**RFI RESPONSE  
NO. RFI-R-01-R1**

<u>To:</u>	CFIA 93 Mt. Edward Road, Charlottetown, PEI	<u>Project:</u>	<b>CFIA Fallowfield Lab Retrofit 3851 Fallowfield Road, Ottawa, ON K2H 8P9</b>
<u>Att:</u>	Mr. Blair Murphy, Project Leader	<u>Project No.:</u>	<b>H0541 (RMA)15181</b>
<u>CC:</u>	Ms. Lisa Lacasse, Contracting Specialist	<u>Date:</u>	<b>02/02/2016</b>

**Title: RMA RFI Response****1. Question:**

4 ELECTRICAL ROOM LAYOUT  
E201 1:20

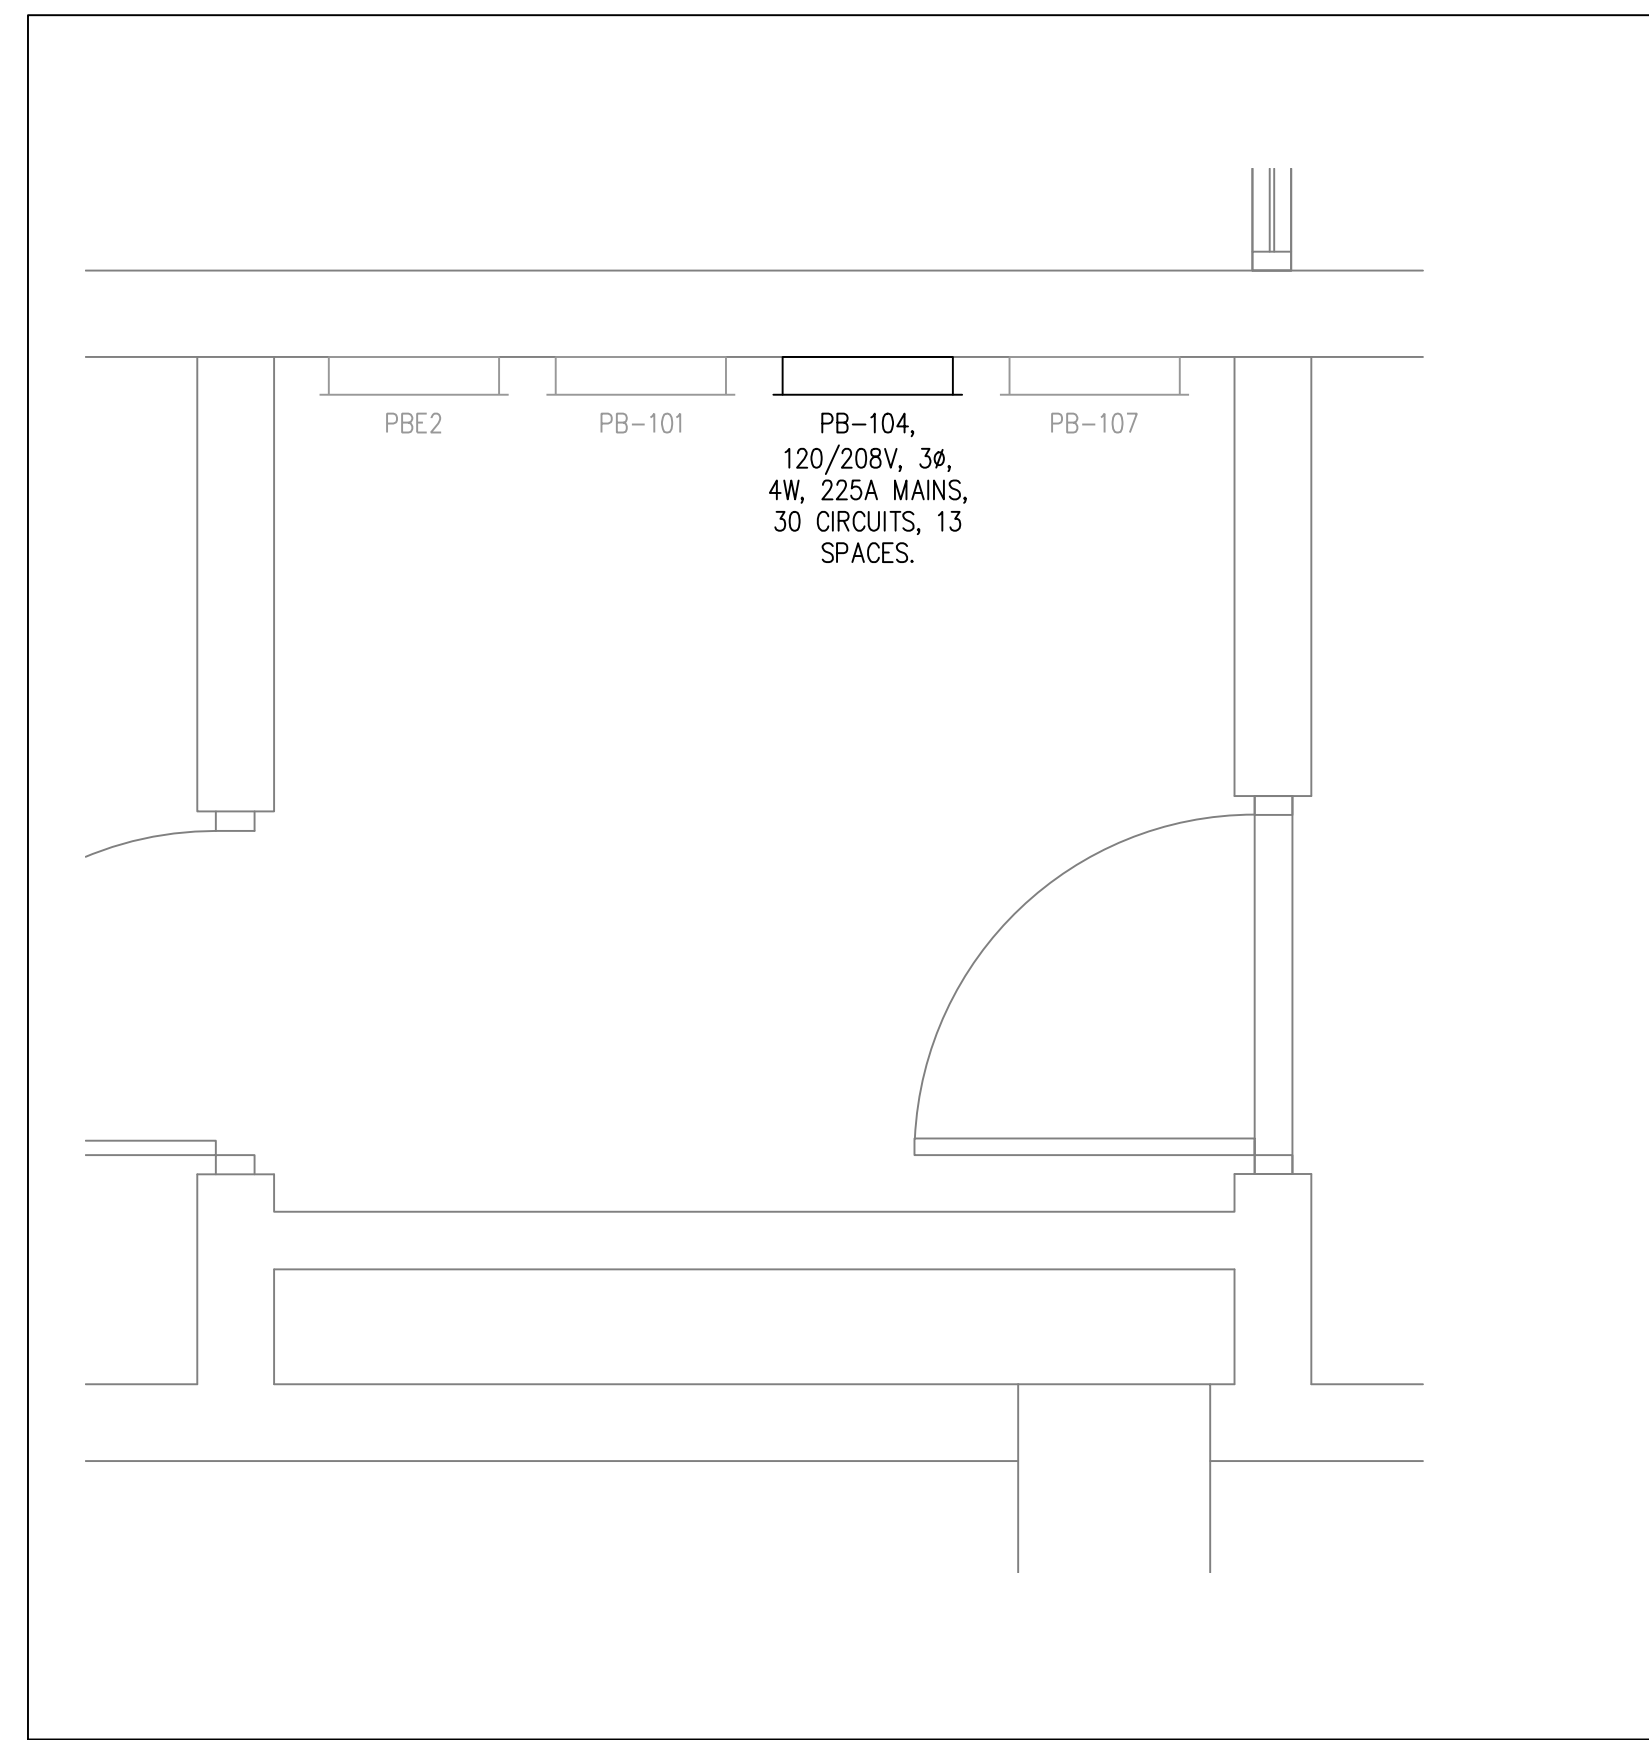
Where is the panel PB-for power for the washrooms. Is there space in the panel?

Où est situé le panneau électrique PB pour l'alimentation des salles de toilettes? Est-ce qu'il contient des espaces libres?

*See attached drawing.*

*Voir le dessin attaché.*
